COUNCIL ASSESSMENT REPORT

Panel Reference	2016SYE016
DA Number	2015/177
LGA	Strathfield
Proposed Development	<p>Use of an existing industrial site as a waste transfer station capable of separating the following non-putrescible waste:</p> <ul style="list-style-type: none"> • Paper and cardboard; • Mixed metals (steel/tin/aluminium); • Glass; and • Mixed plastics.
Street Address	14-82 Madeline Street, Strathfield South Lot 2 in Deposited Plan 556743
Applicant/Owner	Polytrade Pty Ltd
Number of Submissions	<p>Original Notification: (30) written submissions and one (1) petition containing (455) signatures</p> <p>Notification following deferral/amendments: (10) written submissions</p>
Regional Development Criteria (Schedule 4A of the Act)	Designated Development: Waste Transfer Station
List of all relevant s79C(1)(a) matters	<p>List all of the relevant environmental planning instruments: s79C(1)(a)(i)</p> <ul style="list-style-type: none"> • State Environmental Planning Policy (Infrastructure) 2007; • State Environmental Planning Policy No. 33 – Hazardous and Offensive Development; • State Environmental Planning Policy 55 – Remediation of Land; • Strathfield Local Environmental Plan 2012

Image 1 – Excerpt from Council's Flood Study: Subject site outlined in yellow

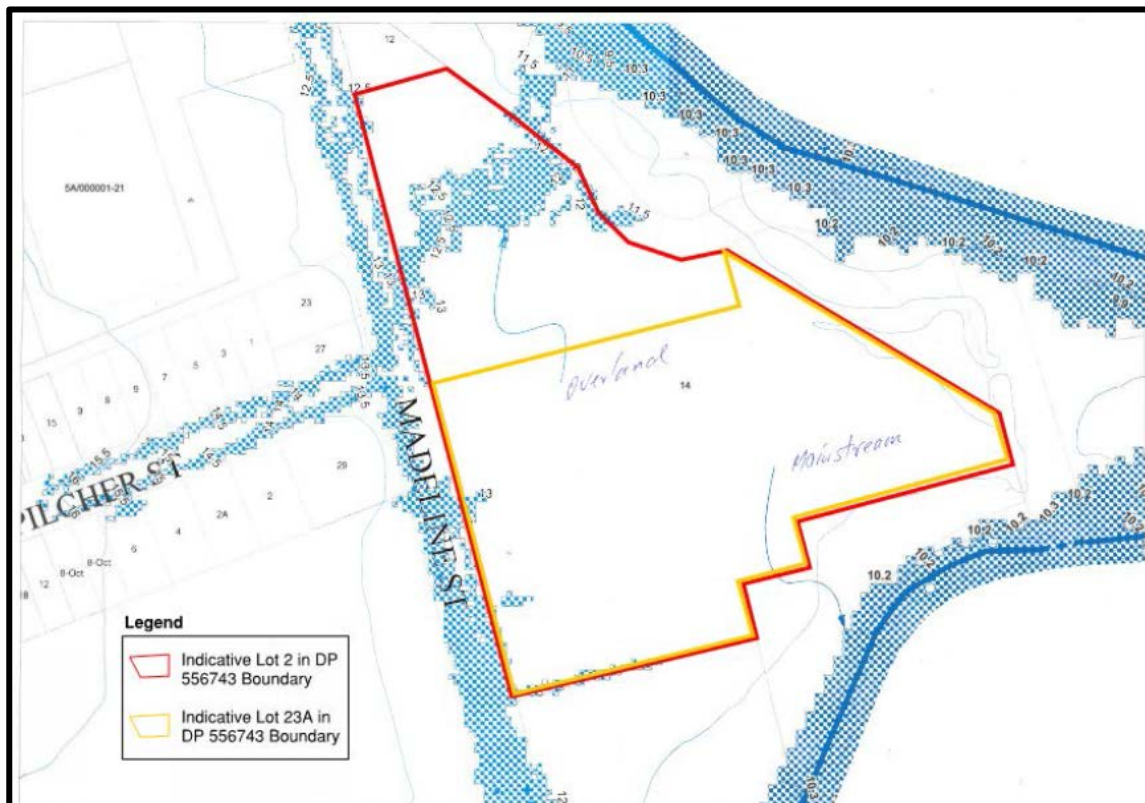
Council's Cooks River Flood Study demonstrates that the site is not affected by mainstream flooding from the concrete lined Cooks River channel however a small portion of the frontage of the subject site is affected by overland flooding in the 1 in 100 year storm event.

The portion of the subject site which is affected by overland flow contains car parking and the hand stand manoeuvring area to the west of the proposed glass bunkers.

As the proposed sorting areas are located within buildings and are separated from the portion of the site which is affected by overland flow, further consideration of the impact on flooding is not deemed necessary.
